Departments Reference: SSD-8571481

EXHIBITION OF EIS - TAFE NSW WESTERN SYDNEY CONSTRUCTION CENTRE OF EXCELLENCE HUB - 2-44 O'CONNELL STREET, KINGSWOOD

Attachment A

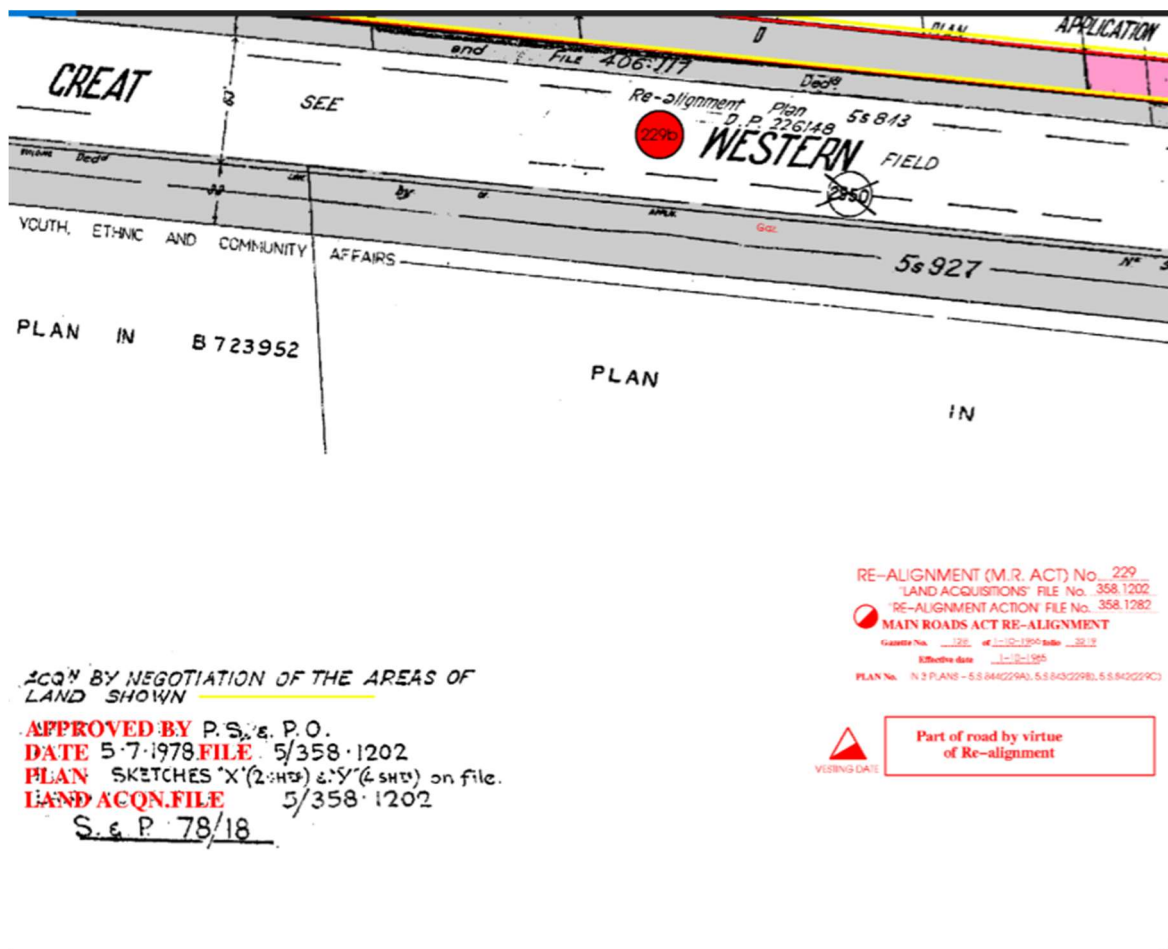
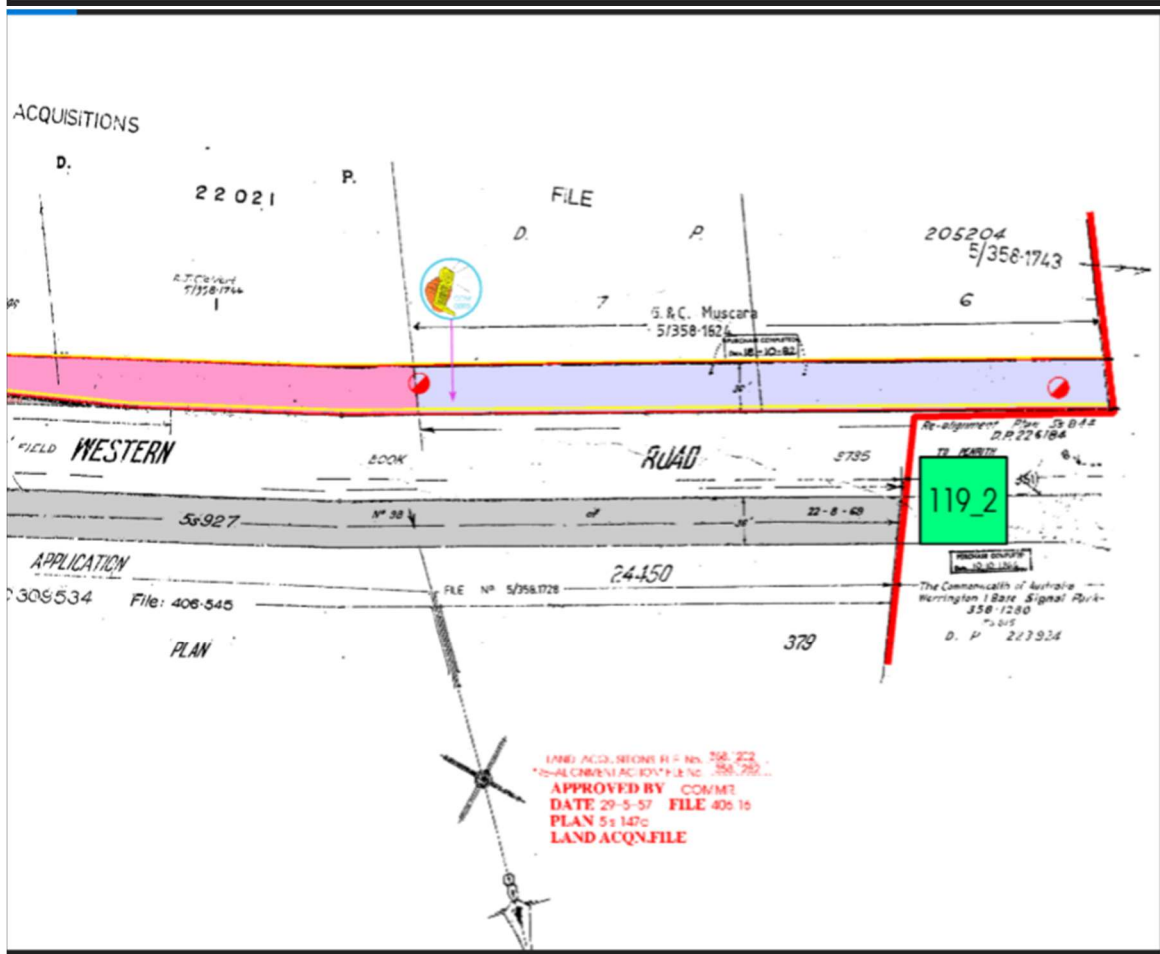
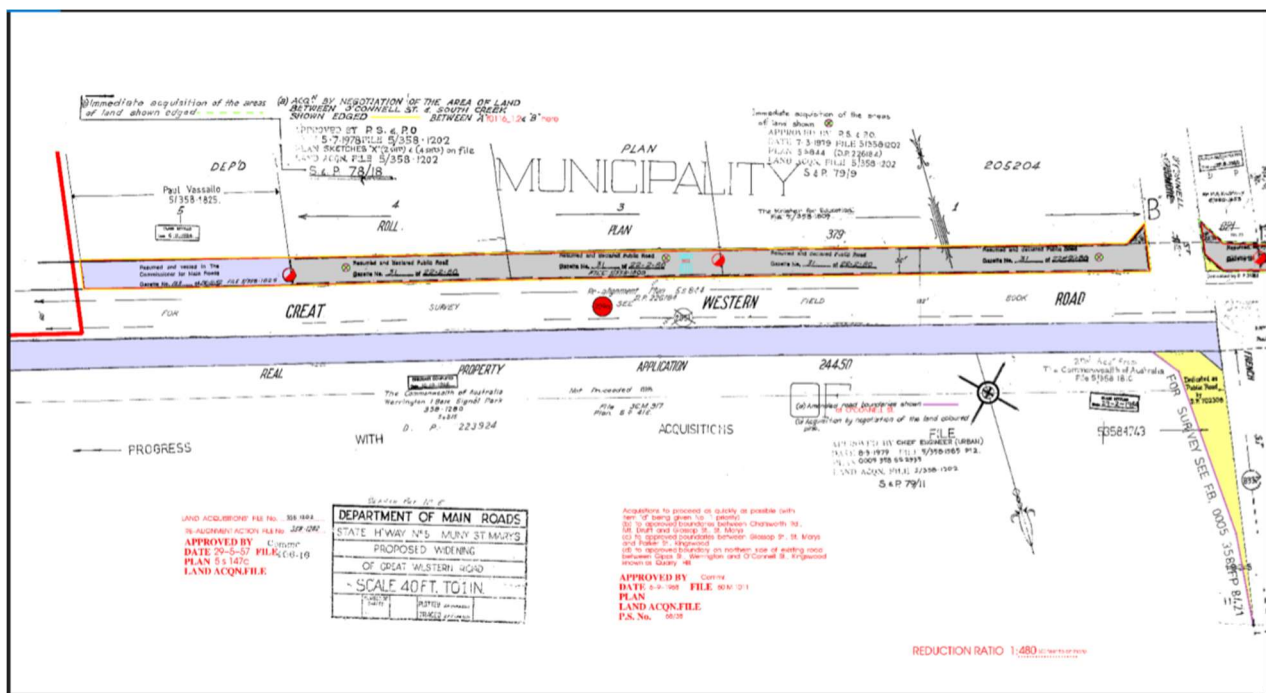
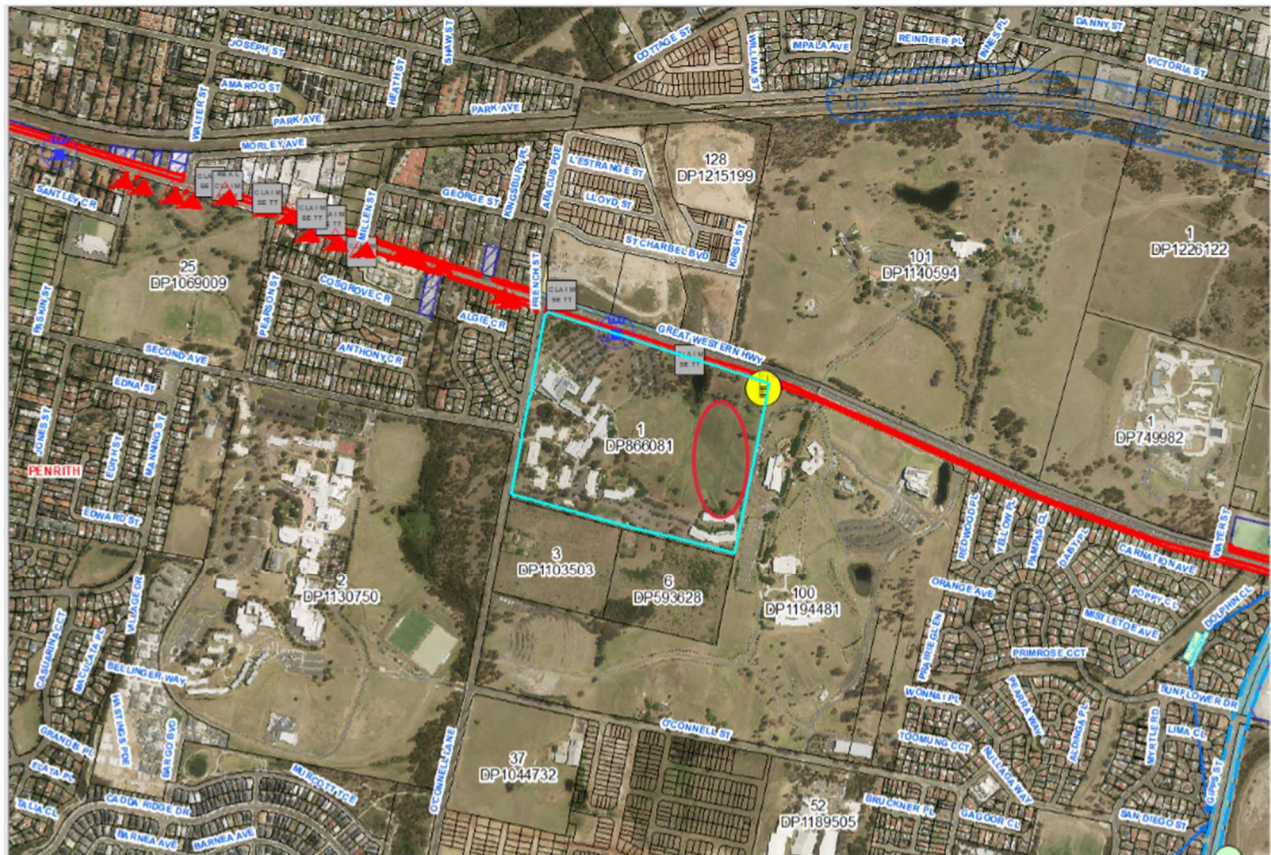
Transport for NSW has previously acquired a strip of land for road along the Great Western Highway frontage of the subject site, as shown by blue colour on the attached Aerial – “X”.

TfNSW (Roads) has previously vested a strip of land as road along the Great Western Highway frontage of the subject site, as shown by grey colour on the attached Aerial – “X”.

As at the date of this response TfNSW has no other proposal which currently requires any part of this Site.
